Request of Class II Permissive Change

FCC ID: 2AKIT-AK022

This is to request a Class II Permissive Change for FCC ID: 2AKIT-AK022, Originally granted on 04/11/2019

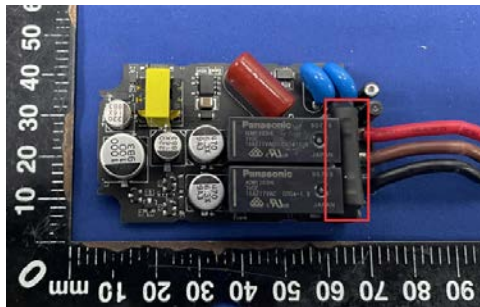
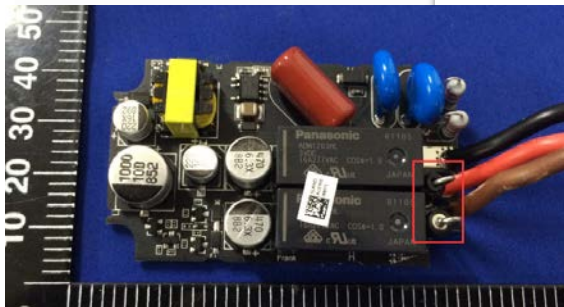
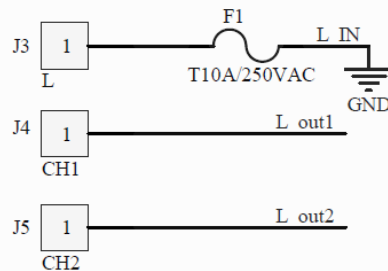
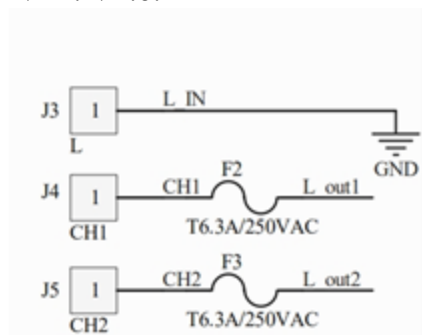
1. Replace the low section fuse with the high section fuse.

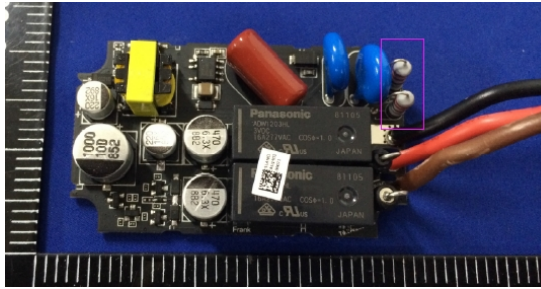
2. Replace the insurance resistance in the power supply circuit with the temperature insurance resistance.
FVIN: V1.0.1

Based on these changes only radiated emissions(30MHz ~ 1GHz) and conduction emissions require retest
